ADDENDUM NO. 2
DATED January 27th, 2021
TOWN OF WOLFEBORO, NEW HAMPSHIRE
RAPID INFILTRATION BASIN SITE REMEDIATION

FLOW CONTROL STRUCTURE DETAILS	
RIB SITE REMEDIATION	
TOWN OF WOLFEBORO	
WOLFEBORO, NEW HAMPSHIRE	
DWG NO	C11
SHEET	13 OF 25

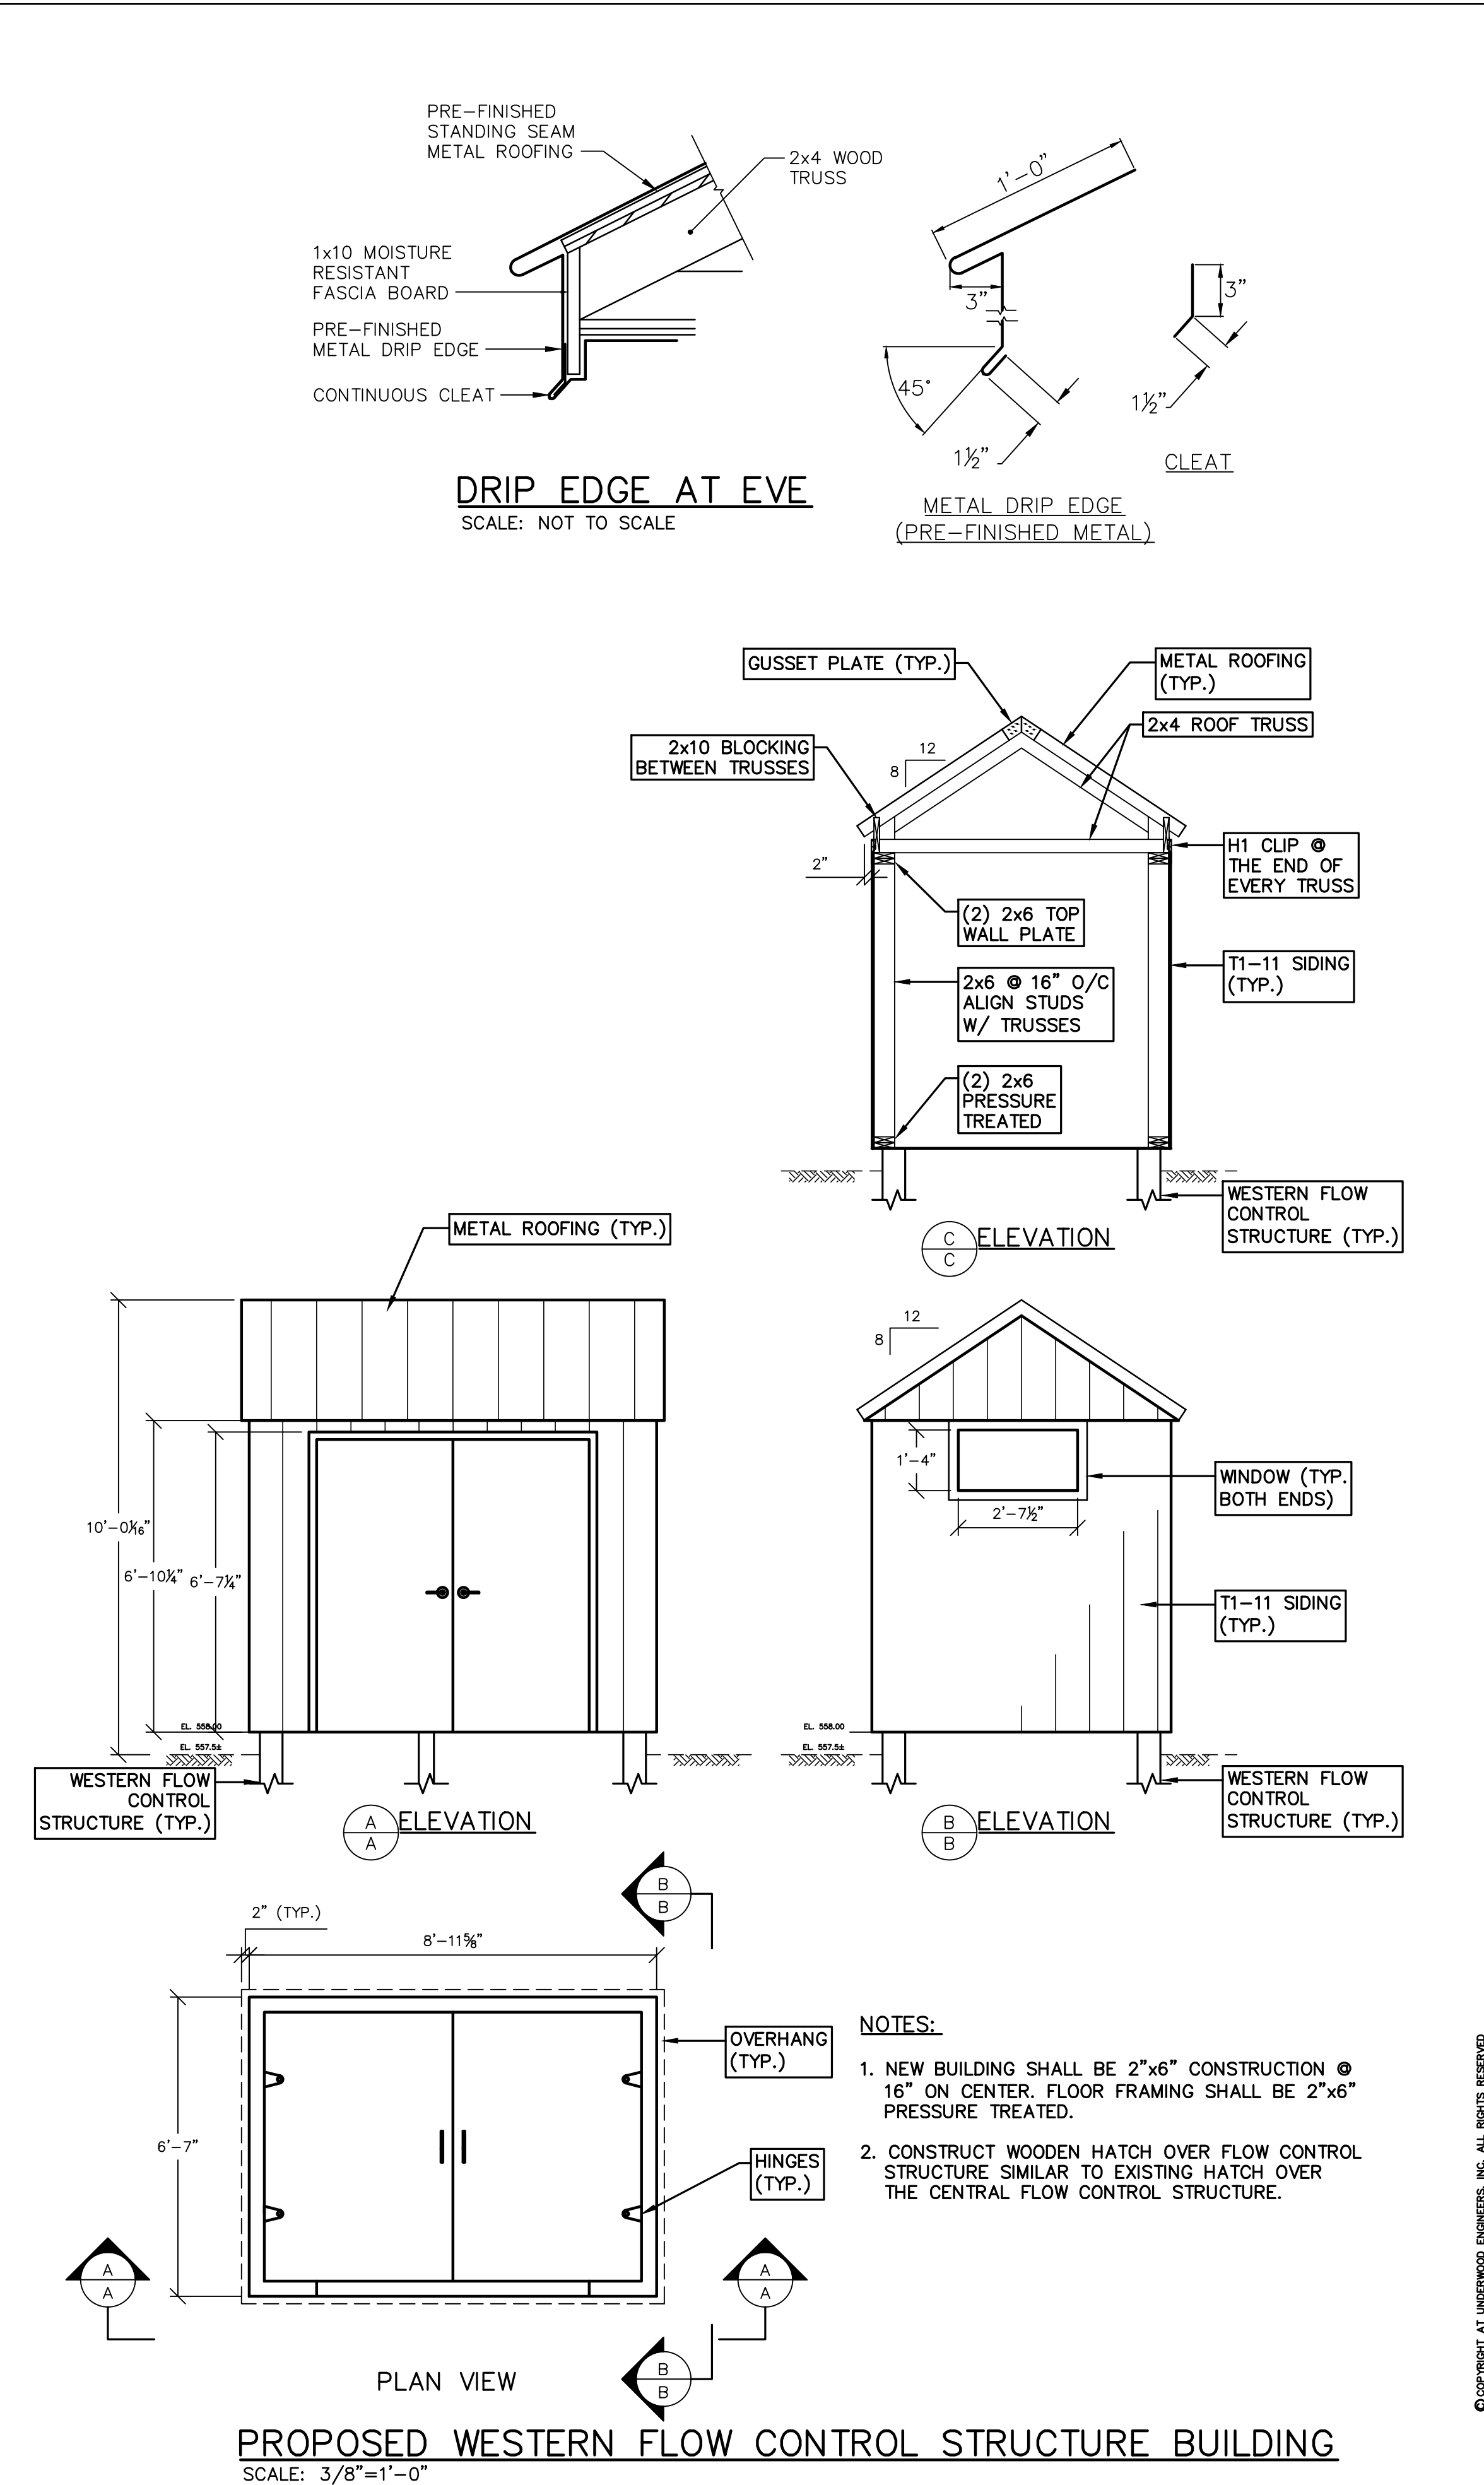
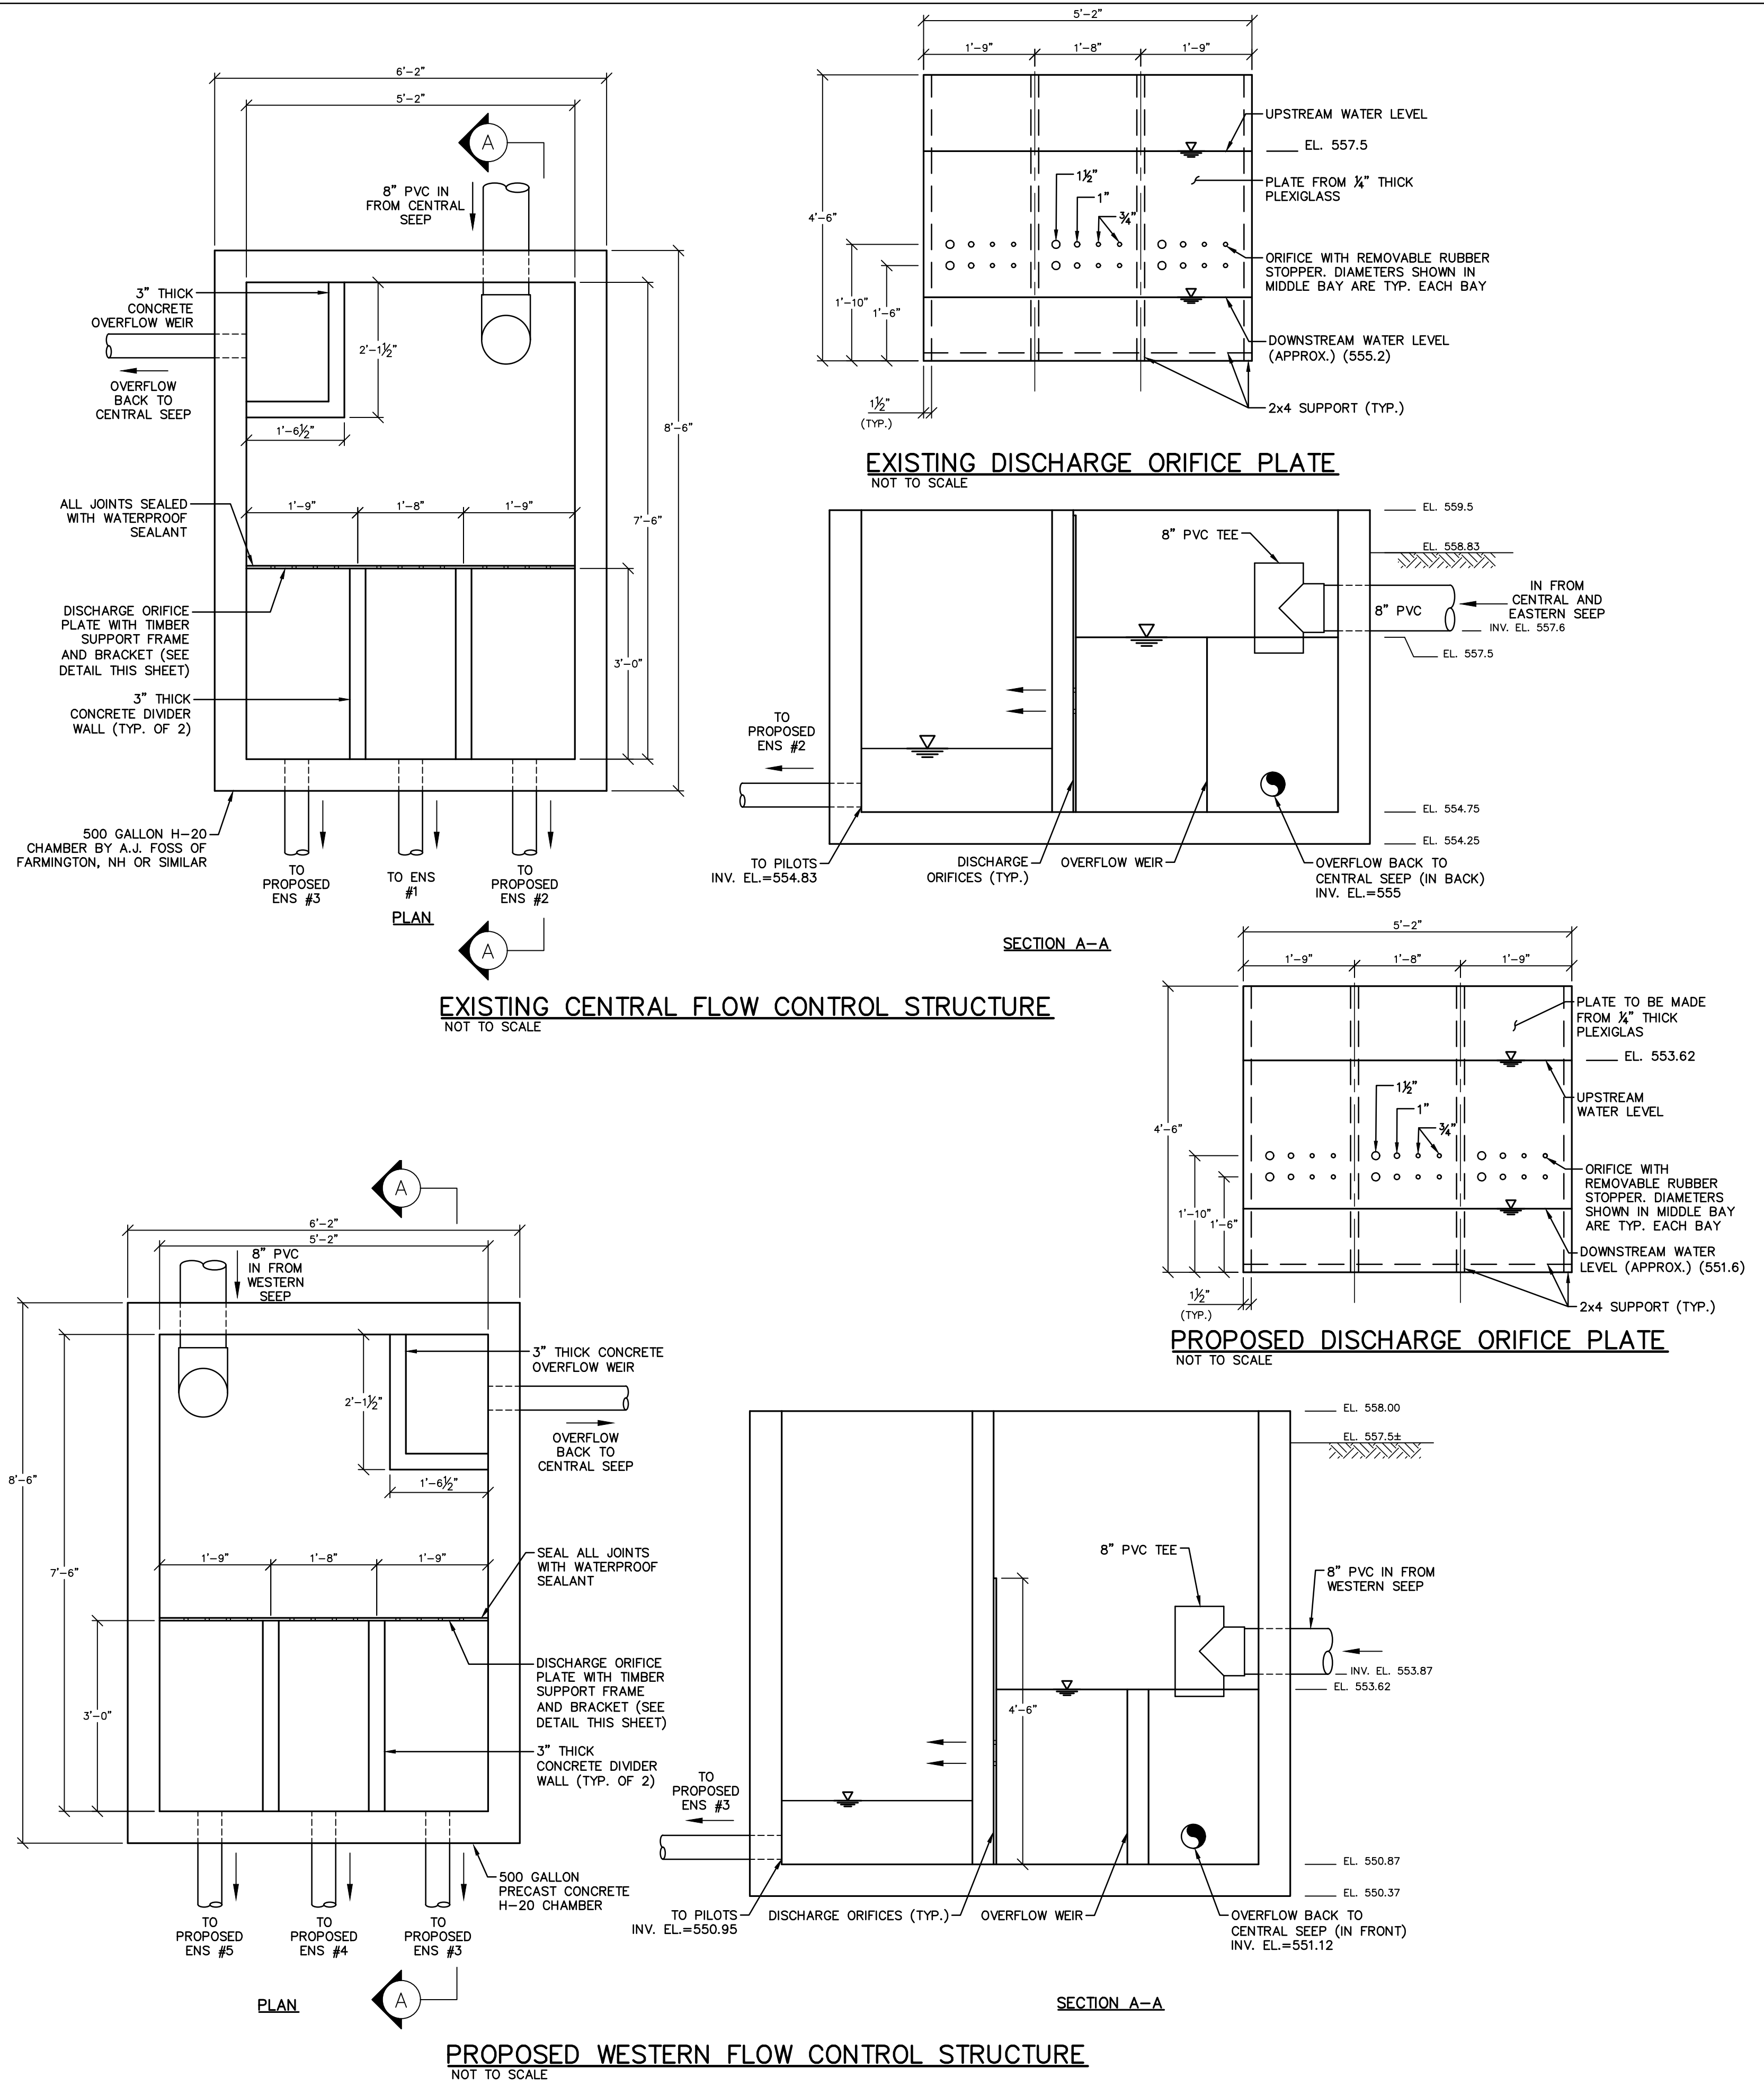
- 1. Drawing C11:** Delete the existing C11 Drawing and replace it with the attached C11 Drawing. Add details shown on the attached Figure 1.

Q8: On Drawing C11, does the proposed Western Flow Control Structure have a concrete wall running parallel to the plexiglass discharge plate?

Q9: On Drawing C11, do the 3” thick concrete divider walls in the proposed Western Flow Control Structure get poured in place after installation of the concrete chamber, or in the precast plant prior to shipment?

A8: No, there is not a concrete wall running parallel with the plexiglass discharge plate. There are two 3” thick concrete divider walls and the plexiglass discharge plate is supported by 2”x4” timber and mounted via metal frames and brackets. Photographs 11 & 12 in the Pre-bid Minutes show the existing flow control structure.

A9: It is the Contractor’s choice whether the 3” thick divider walls are formed and poured onsite or included with the precast structure.
